UNITED STATES ENVIRONMENTAL PROTECTION AGENCY
REGION IX
75 Hawthorne Street
San Francisco, CA 94105

February 4, 2014

Re: Toxic Substances Control Act, Polychlorinated Biphenyls (PCBs) – PCB Cleanup, Former Pechiney Cast Plate Facility, Vernon, California – AMEC's Proposed Modifications to USEPA's Approvals

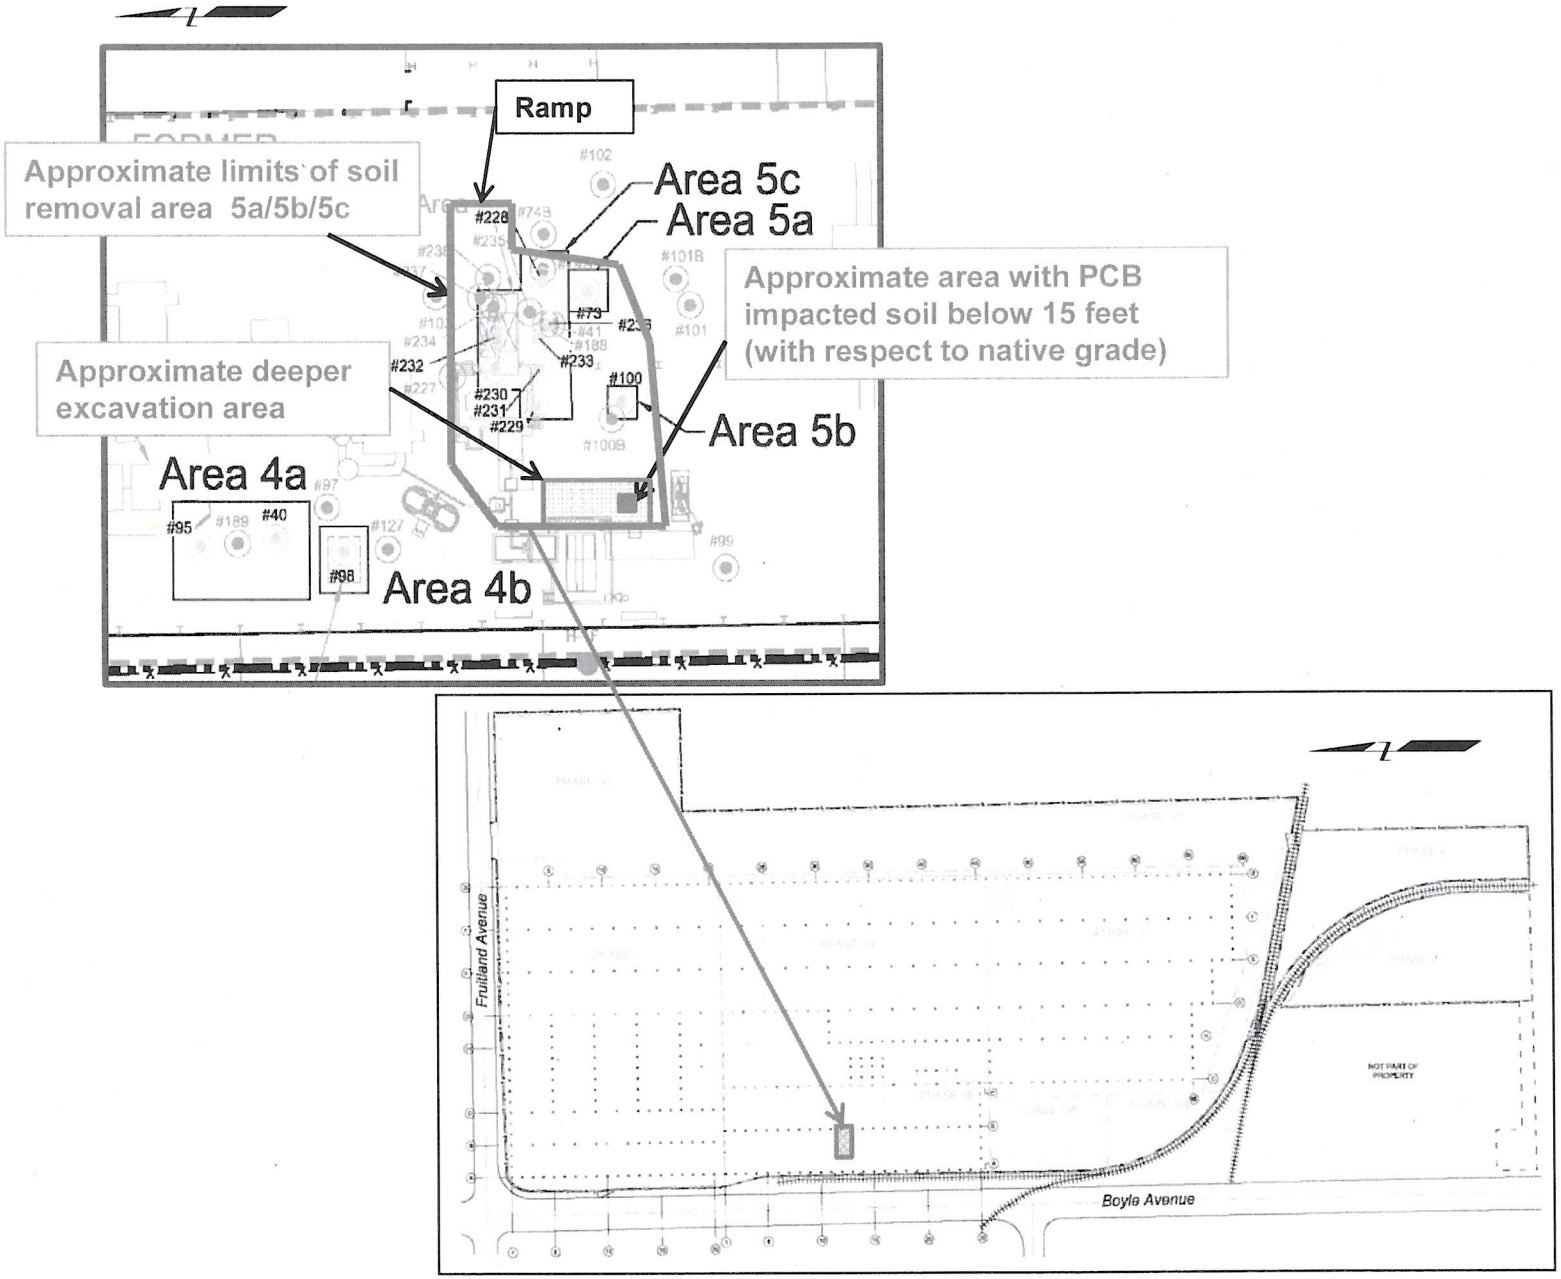
3) **PCB impacted soil at depths below 15 feet.** PCB-impacted soil at depths greater than 15 feet (below native grade) has been encountered in the soil removal area 5a/5b/5c areas (also referred to the Area C in our Application and the 2012 RAP). In this area, the existing concrete slab is about 4 feet above native site grade. The base of the deeper portion of the soil removal area (shown in blue on the attached figure) is currently at about 21 to 30 feet below the slab (or about 17 to 26 feet below native grade) depending on the location on the excavation floor. In the southern portion of the deeper excavation, soil containing PCBs at concentrations exceeding 23 mg/kg (actual measured concentration at this location is 73.6 mg/kg) is proposed to be left in place at an approximate depth of 26 feet below native grade. These site conditions are similar to the site conditions as specified in the Conditional Approval (refer to Section C.3.b.6; July 2, 2010 Conditional Approval letter and site grading plan) for the proposed 4a/4b soil removal area.

The proposed modification to the Approval includes placing a physical barrier consisting of a minimum of 6 inches of concrete or cement slurry over the PCB-impacted soil at depth of greater than 15 feet below native grade. This modification will be applied to any areas where soil containing PCBs at concentrations greater than 23 mg/kg at depths greater than 15 feet below native grade with conditions consistent with the Approval for the proposed 4a/4b soil removal area. At this time, this modification is only expected to be applied to the 5a/5b/5c (Area C) excavation. For Area C, a cement-slurry in lieu of the concrete may be used based on worker safety

conditions which do not allow direct placement of concrete and pumping of cement-slurry may be required to place the cover. Based on the depth and location of the soil that will remain in place and the physical barrier, disturbance of the PCB-impacted soil at depths greater than 15 feet below native grade is not anticipated during future site grading.

Additional sampling is in progress pursuant to Section 2.3 [Soil Verification Sampling (PCBs) in the July 2010 Concrete and Soil Sampling and Analysis Plan (SAP)]. But because the Area C soil excavation is becoming unstable, backfill of Area C is expected to occur during the week of January 27, 2014. Based on the results of the verification samples, the area of the excavation where PCBs in soil may be left in place at a depth of 15 feet below native grade will be covered with a minimum of 6 inches cement slurry or concrete, which will be overlain with an orange mesh geotextile layer. The base of the excavation and concrete layer will be surveyed to document the depth and location of this feature. The remainder of the excavation will be backfilled with crushed concrete (defined as unrestricted site fill material).

USEPA Modification to Approvals #1 and #2. The total PCB and Aroclor 1254 concentration in soils below 15 feet below ground surface (bgs [i.e., below native grade]) must be confirmed via collection and analysis of in-situ, discrete samples during underground demolition, if such data does not exist already. Soils below 15 feet bgs are defined here as Deep Soils.

Deep Soils verified to contain total PCBs above 23 mg/kg and/or Aroclor 1254 above 2.0 mg/kg (when Aroclor 1254 is the only Aroclor detected) shall be remediated to these cleanup levels, if feasible. Best efforts to remediate the Deep Soils (below 15 feet bgs) may not result in achievement of these cleanup levels. An *"Alternative"* is provided below to address those situations. That *Alternative* intends to account for a balance between environmental and human health benefits derived from removal of Deep Soils exceeding PCB cleanup levels and potential increases in air emissions and energy spent by excavation equipment used to remove those Deep Soils. In addition, landfill capacity should also be considered.

Alternative: Deep Soils (below 15 feet bgs) exceeding 23 mg/kg total PCBs and/or 2.0 mg/kg Aroclor 1254 (where Aroclor 1254 is the only detected Aroclor) before or after soil excavation and removal, may remain in place if:

(a) Up-to-date grading plans for the Pechiney property demonstrate the Deep Soils will not be disturbed during grading of the property, pre-construction, construction, post-construction, and/or post-redevelopment activities at the property;

(b) A physical underground warning barrier (UWB) that is effective for the long term is installed at the floor of the 5 to 15 feet bgs PCB-remediation interval for soils. The UWB will warn about the presence of Deep Soils beneath the UWB exceeding the cleanup levels for the 5 to 15 feet bgs remediation interval.

In certain situations, excavation and removal of Deep Soils may be necessary to facilitate sampling and removal, or sampling and capping of certain underground structures during underground demolition. In those instances, the UWB would be constructed at a depth deeper than 15 feet bgs and above the Deep Soils verified to exceed the cleanup levels for the 5 to 15 bgs remediation interval.

Regardless of its location, if the UWB is encountered during grading, construction, post-construction, and/or post-redevelopment, such activities must be halted and the soil management plan must be immediately activated and implemented;

(e) A survey is conducted to document (1) the location and depth of final excavation floors and UWBs; and (2) total PCB and Aroclor 1254 concentrations in Deep Soils left in place below all UWBs and in left-in-place underground structures (as feasible), as well as, the location and depth of those Deep Soils.

The UWB shall be constructed with concrete or cement slurry or other suitable material that allows a completion thickness of 6 inches for the UWB. The UWB shall be overlain by a colored (e.g., orange) mesh geotextile layer.
